East Side Coastal Resiliency Project: Final Scope of Work to Prepare a Draft Environmental Impact Statement

East Side Coastal Resiliency

Final Scope of Work to Prepare a Draft Environmental

April 5, 2019

Capital Project SANDRESM1 EAST SIDE COASTAL RESILIENCY Urban Design and Visual Resources Study Area **Figure 20**

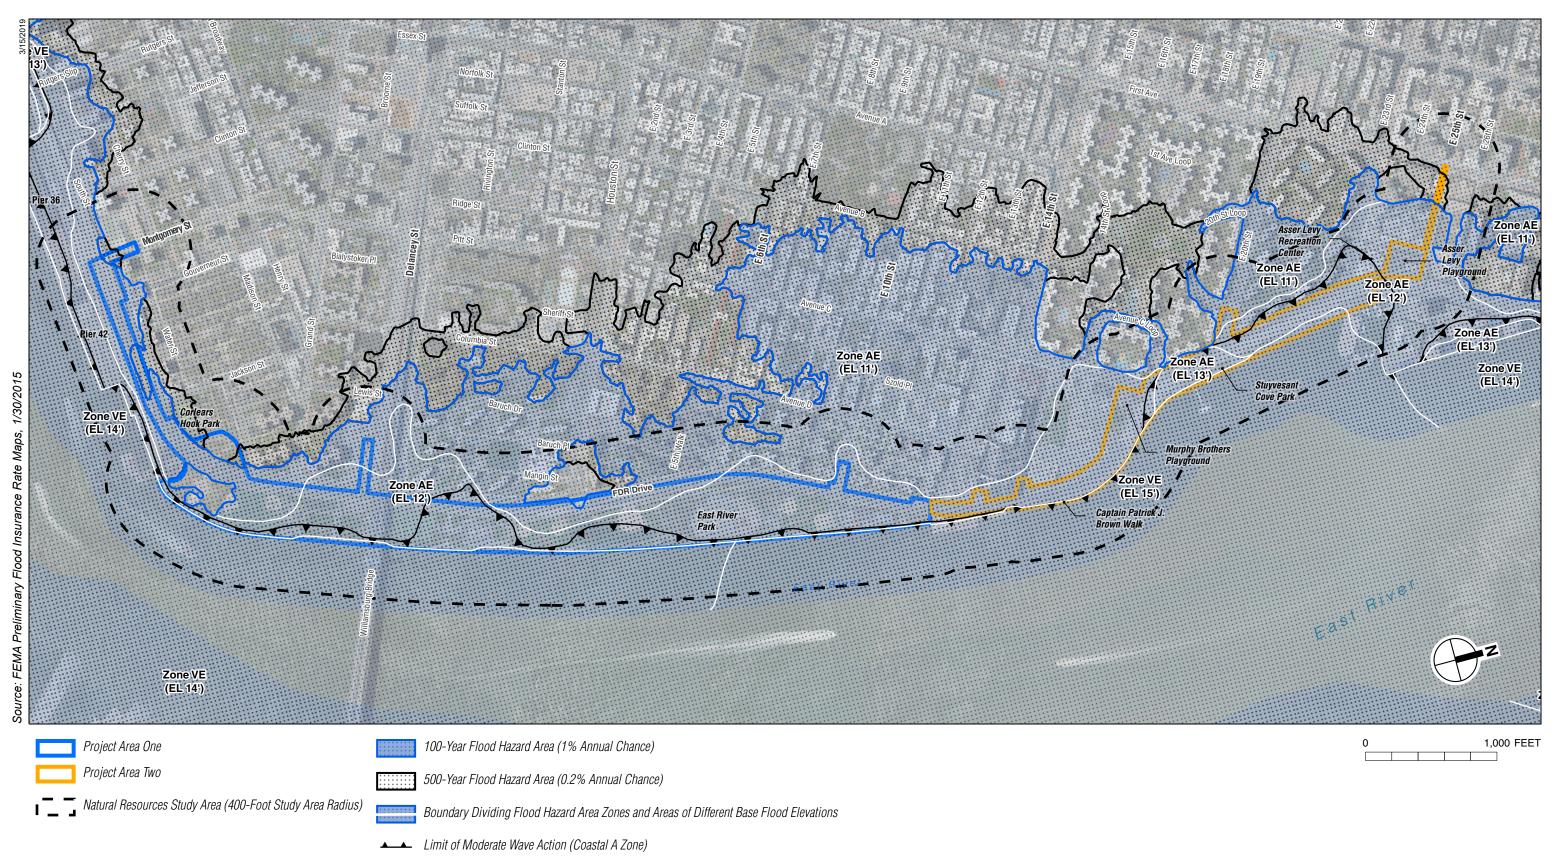
- **Comment 67:** Correction to Figure 18: The northward Avenue C view corridor (toward the Queensboro Bridge) is an important view corridor, but here is not shown by any arrow in the drawing. I suggest that it be included and also include the direction that whatever deployables are going to be utilized are oriented so that this view corridor is preserved. (Scheyer)

- **Comment 69:** With the new East 10th Street Bridge, we're not going to be able to have a view. (Velez)
- **Response:** As shown on Figure 20 of the Draft and of this Final Scope of Work, the East 10th Street view corridor to the waterfront will be assessed in the EIS.

- **Response:** As described in the Draft Scope of Work, Figure 20—Urban Design and Visual Resources, Study Area and Visual Corridors—provided a preliminary identification of existing inland views to the waterfront. Figure 20 in this Final Scope of Work has been modified to include the northward view corridor from Avenue C, which will be evaluated in the EIS.
